STAFF RECOMMENDATION
722 McFerrin Avenue
June 17, 2020

Application: New Construction - Infill
District: Maxwell Heights Neighborhood Conservation Zoning Overlay
Council District: 05
Base Zoning: MUN-A
Map and Parcel Number: 082080286
Applicant: Brandon Williams
Project Lead: Jenny Warren, jenny.warren@nashville.gov

<p>Description of Project: Application for new construction of a mixed use building.</p> <p>Recommendation Summary: Staff recommends denial of the application, finding that the project does not meet the following design guidelines:</p> <ul style="list-style-type: none">• Sections II.B.1.a.and b for height and scale• Section II.B.1.c for setback and rhythm of spacing• Section II.B.1.e for roof form• Section II.B.1.f for orientation• Section II.B.1.g for proportion and rhythm of openings.	<p>Attachments A: Photographs B: Site Plan C: Elevations</p>
----------------------------------------------------------------------------------------------------------------------------------------------------------------------------------------------------------------------------------------------------------------------------------------------------------------------------------------

Figure 11: 720 McFerrin Ave

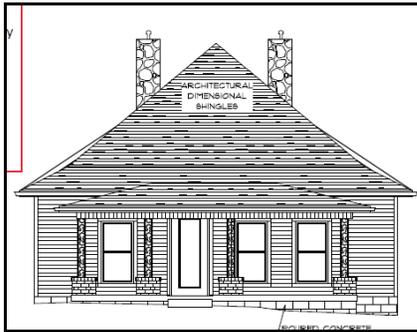
The new construction has a flat roof form, so the entire building would be a full twenty-eight feet, six inches (28'6") high and would sit next to a historic house with a height of about twenty-one feet (21') to the peak of its hipped roof. (Figure 11). For reference, the highlighted line across Figure 12 is marked on the plans as twenty feet (20') high. So the peak of the roof at 720 McFerrin (Figure 11) will be just above this line. The right hand eave of 720 is about ten feet (10') high, and the red line on the plan for 722 McFerrin is marked at eleven feet (11'). As a streetscape was not provided, Figures 9 & 10 and been roughly aligned to show the high comparison.

Staff finds that the height is not appropriate for the historic context and should not be taller than about twenty-one to twenty-seven feet (21'-27') – though a smaller structure could also be appropriate, depending on roof form.

Figure 15: Footprint map showing setbacks from McFerrin. White box indicates approximate appropriate front setback for 722 McFerrin

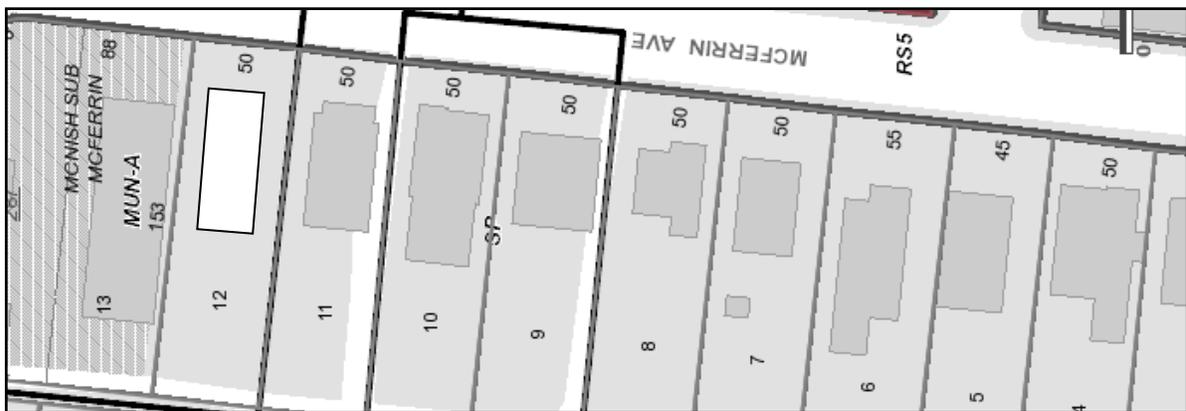
The proposed front setback is eight feet (8') from the sidewalk. All of the historic houses to the left of the subject lot have consistent setbacks at approximately twenty feet (20') from the sidewalk. The infill should match the setbacks of these historic house and should be field checked by staff at staking.

Staff finds that with the front setback adjusted to meet that of the historic house next door at 720 McFerrin, the project will meet section II.B.1.c for setbacks.

Figure 16. Left side elevation

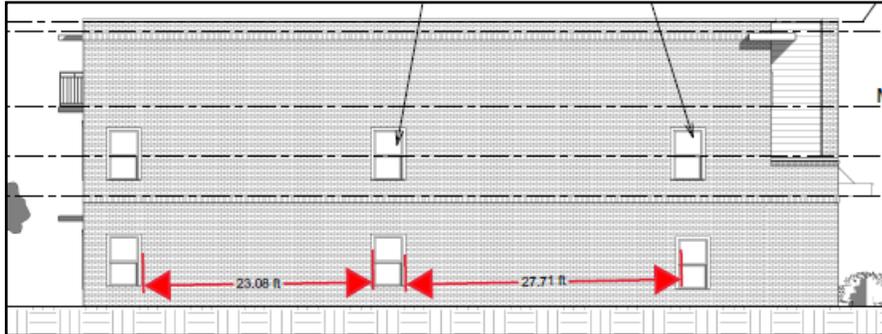
On the front and rear elevations the window and door openings are twice as tall as they are wide, thereby meeting the historic proportion of openings. On the side elevations (Figure 16), the windows are vertically oriented but the third level does not include windows. If the form were appropriate, staff would recommend that there be a window every eight to thirteen feet (8'-13'), and on each level, in accordance with the guidelines. The majority of these windows should be twice as tall as they are wide. The project's proportion and rhythm of openings does not meet Section II.B.1.g.

1 Front Elevation
3/32" = 1'-0"

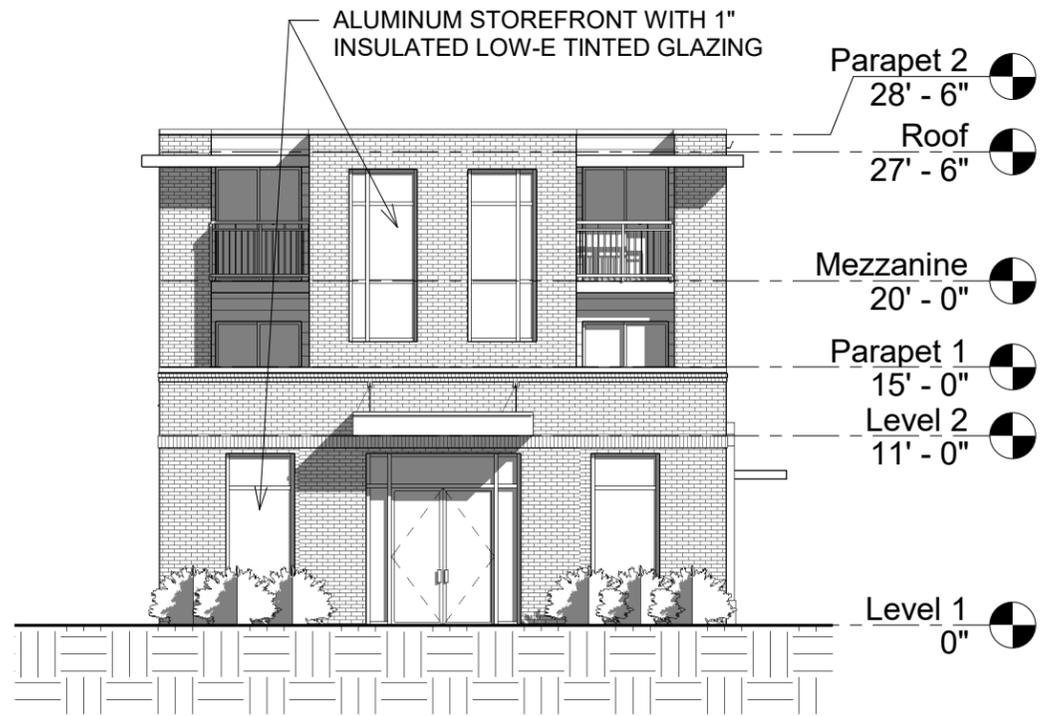
The new construction is proposed to be twenty-eight feet, six inches (28'6") tall. The historic context includes one and one-and-a-half story houses that are between about fifteen and twenty-seven feet (15'-27') tall. See Figures 5-8. Additionally, the historic houses all have pitched roofs, so their heights reflect the peak of the ridge – in other words, only a small portion of the massing of the historic houses are actually this tall.

In addition to the height, the proportions of each level are inconsistent with the district, with the upper level appearing to be one additional story when in fact it is two.

The proposed roof is flat with a parapet. The guidelines state that roofs should have a similar pitch to those found in the district, generally between 6/12 and 12/12. As explained above, under “Height and Scale,” the historic houses all have a pitched roof, so their heights reflect the peak of the ridge – in other words, only a small portion of the massing of the historic houses are actually this tall. The new construction has a flat roof form, so the entire building would be a full twenty-eight feet, six inches (28’6”) high and would sit next to a historic house with a height of about twenty-one feet (21’) to the peak of its hipped roof. Additionally, the flat-roofed form uses no eaves to help mitigate the height of the structure.
